**ADDENDUM NO. 03
September 26, 2022**

**WINDSONG ELEMENTARY SCHOOL ADDITION & RENOVATION ISSUE FOUR PROPOSAL
FOR FRIENDSWOOD I.S.D.**

Prepared by: PBK
11 Greenway Plaza, 22nd Floor
Houston, TX 77046-1104
PBK Project No: 20380

SITE PLAN

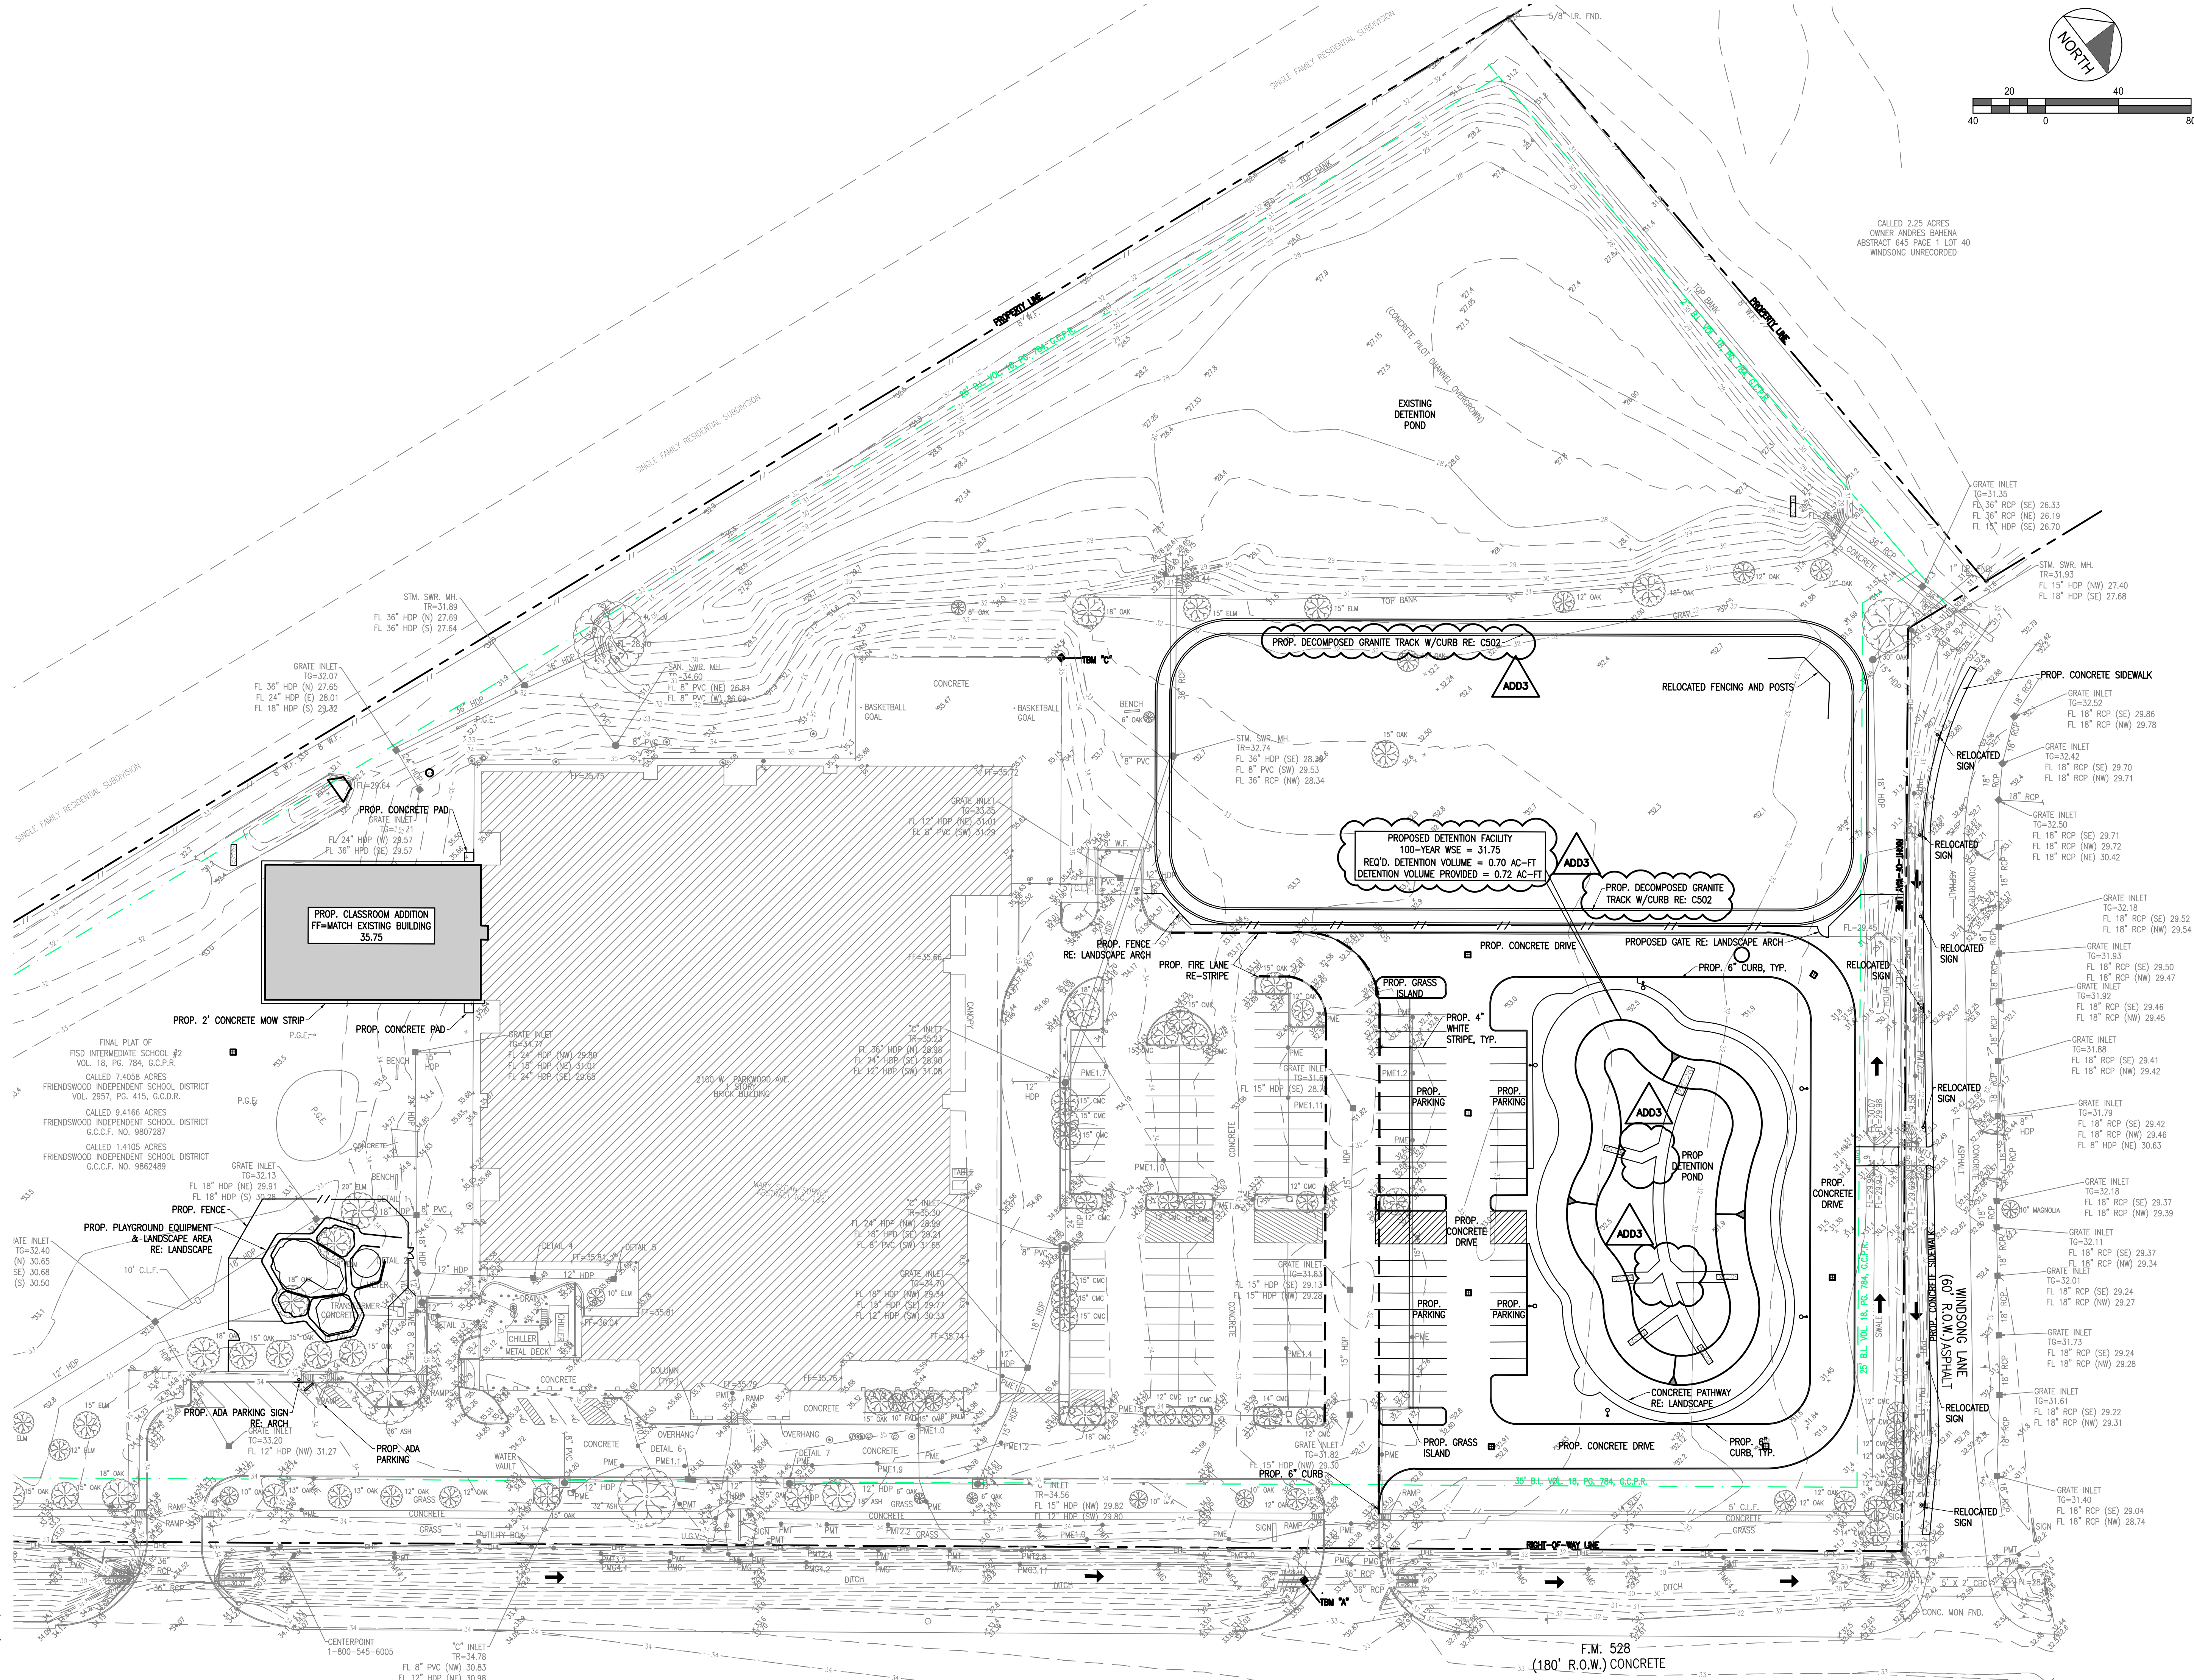
- Item No. 28 C. Updated callout and hatching for stripping of soils around existing trees.
- Item No. 29 **C 101 Site Plan**
- Item No. 29 A. Updated callouts for track to include curb.

- Item No. 29 B. Updated pond 100 year water surface elevation to 31.75 from 31.50.
- Item No. 29 C. Adjusted concrete pilot channel.
- Item No. 30 **C 202 Drainage Plan**

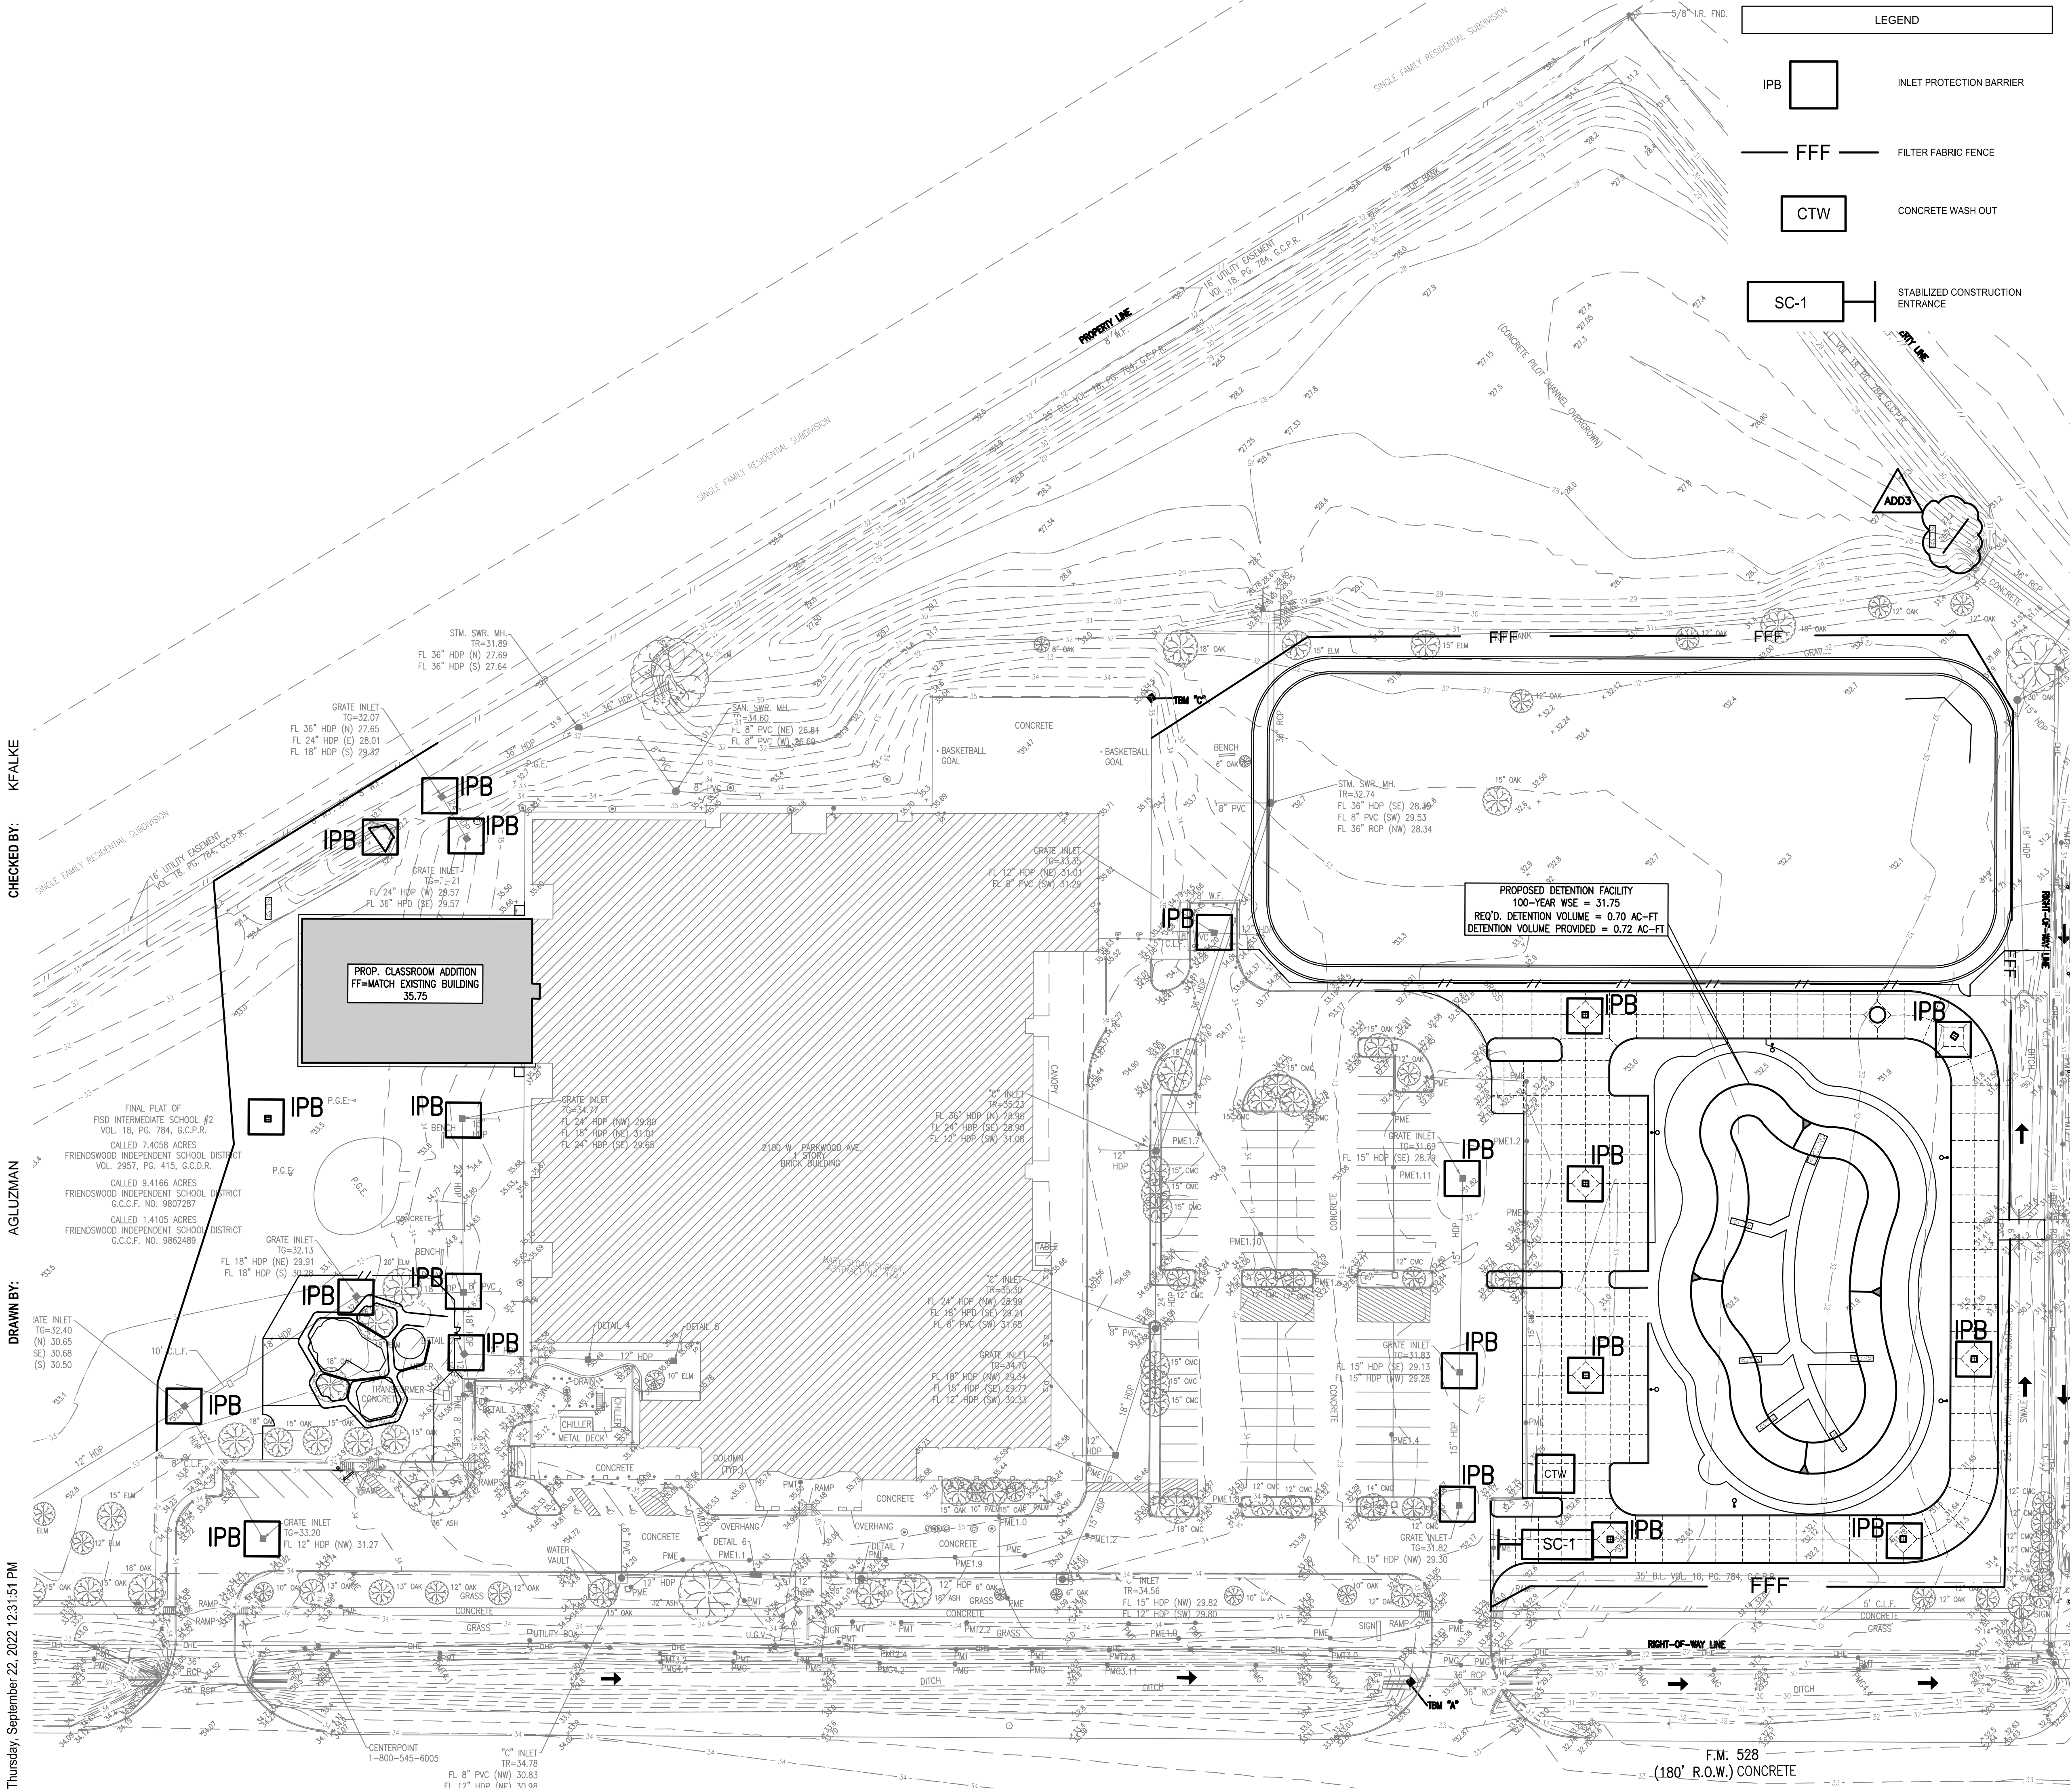
- Item No. 32 A. Updated sheet in its entirety.
- Item No. 32 B. Added restrictor graphs, updated storm sewer calculations per City of Friendswood request.

SD-100

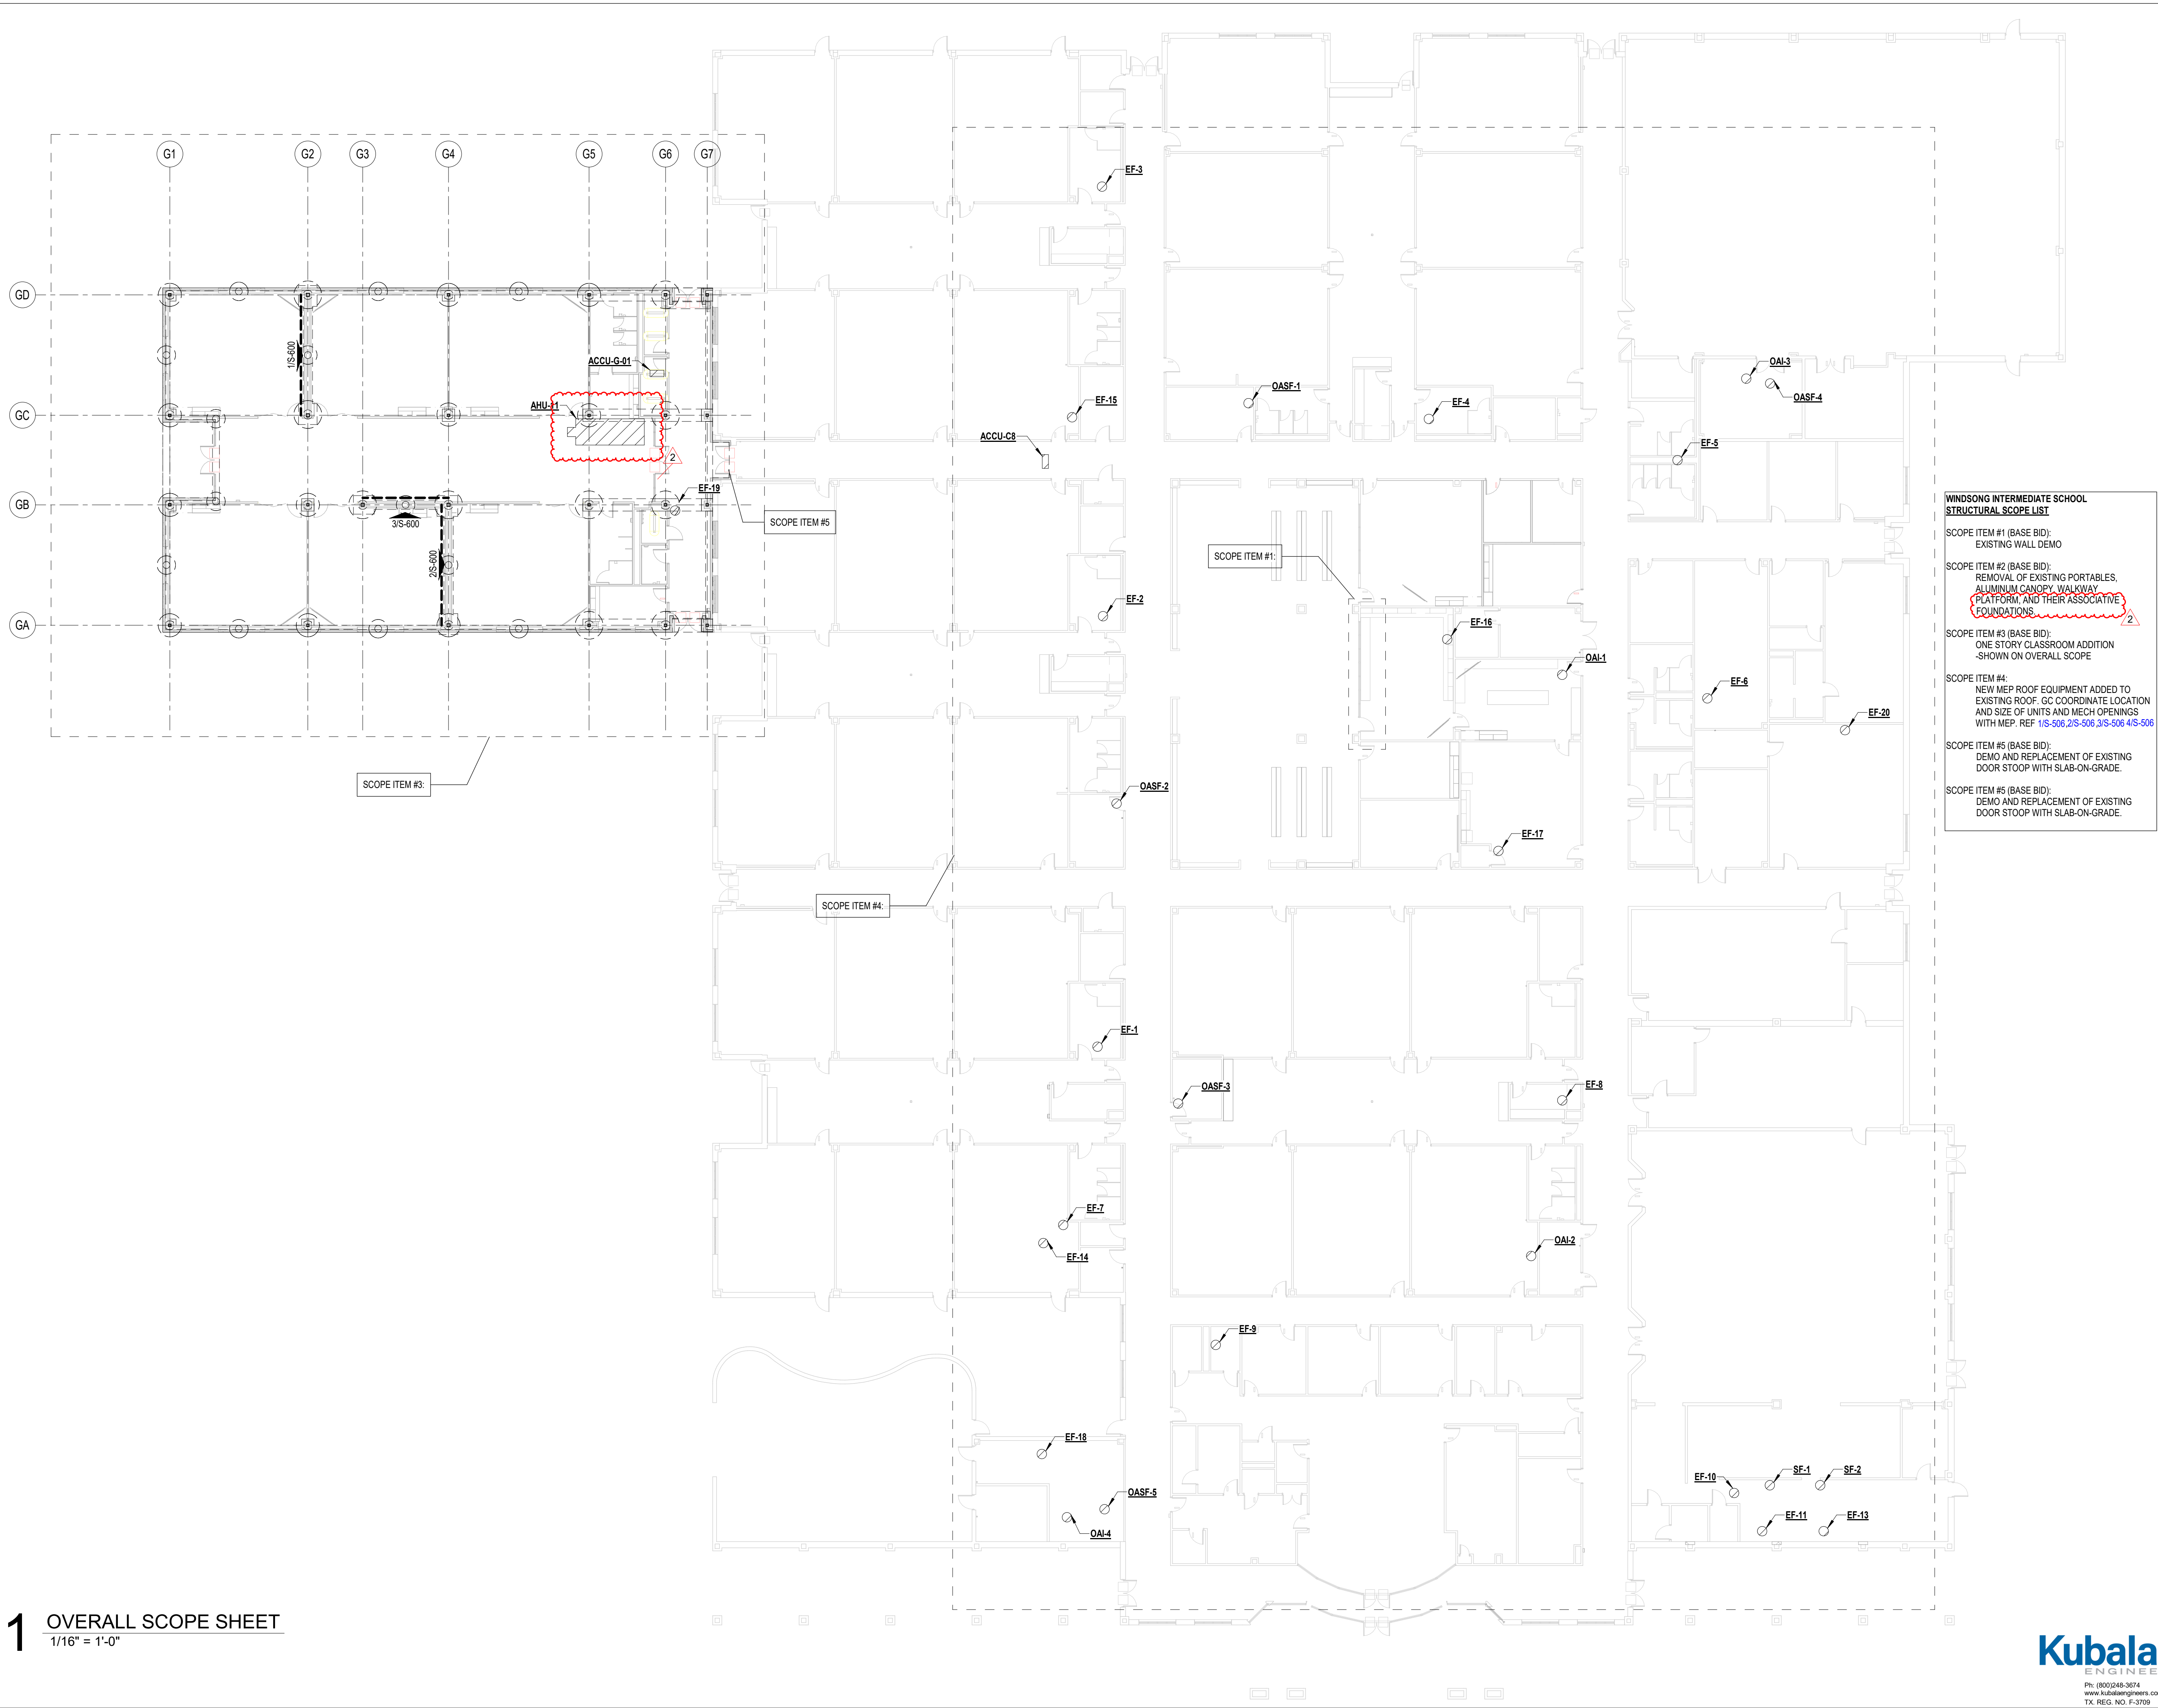
- Item No. 49 **SD-100 – OVERALL DEMO SCOPE SHEET**
A. Scope item #2 note changed in structural scope list. See re-issued sheet.
B. Special GC Note added to sheet. See reissued sheet.
- Item No. 50 **S-100 – OVERALL SCOPE SHEET**
A. Scope item #2 note changed in structural scope list. See reissued sheet.
B. MEP unit shown on plan. See reissued sheet.
- Item No. 51 **S-102G – ROOF FRAMING PLAN – AREA G**
A. MEP roof top unit added to plan. See reissued sheet.
- Item No. 52 **S-506 – GENERAL STEEL NOTES AND TYP DETAILS**
A. Detail 1 revised. See reissued sheet.
